AMERICAN GENERAL AIRCRAFT SERVICE BULLETIN No.176

ALTERNATOR LIGHT CIRCUIT MODIFICATION

99998, 10000 THROUGH 10033

Figure 1. Relay energizer wire routing.

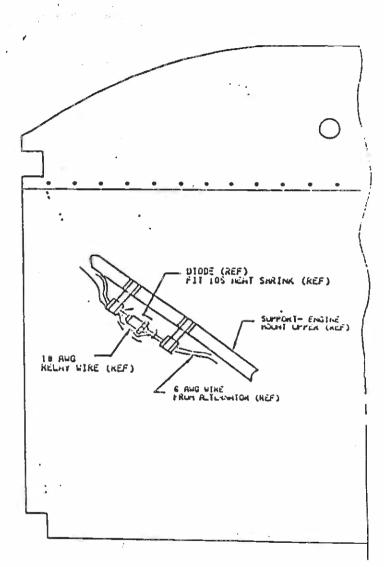
I. Relay energizer wire (location: engine mount, right side) Serials: 99998, 10000 through 10020

Relay energizer wire must <u>not</u> be enclosed in power diode heat shrink to prevent possible insulation damage to relay energizer wire by diode heat and chafing. Inspect routing and replace heat shrink as required.

(1) Locate 18 AWG relay wire attached to power diode, leading from alternater, Figure 1.

(2) If routed through heat shrink tubing wraped around diode: (a) remove heat shrink tubing (b) inspect wire for insulation damage and if damage is present, incase wire in 1/8" heat shrink tubing.
(c) replace heat shrink tubing with 18 AWG wire routed outside of heat shrink tubing.

Figure 2. Relay transient protection diode.

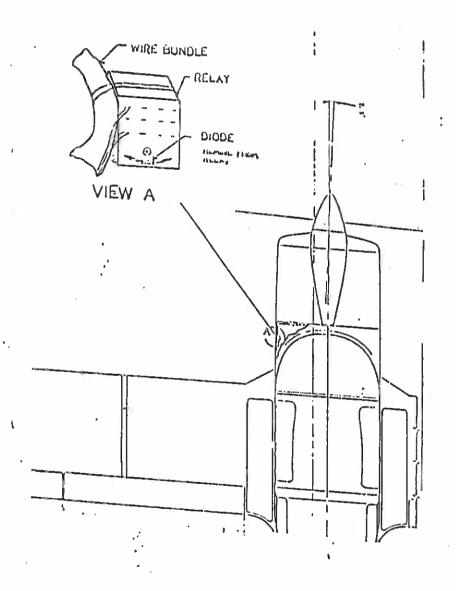
II. Relay transient protection diode (location: left side fusclage, below instrument deck)

The diode is not required and presents a possible short to ground between the relay terminals.

(1) Locate relay in harness bundle, between stall warning horn and avionics cooling fan, Figure 2.
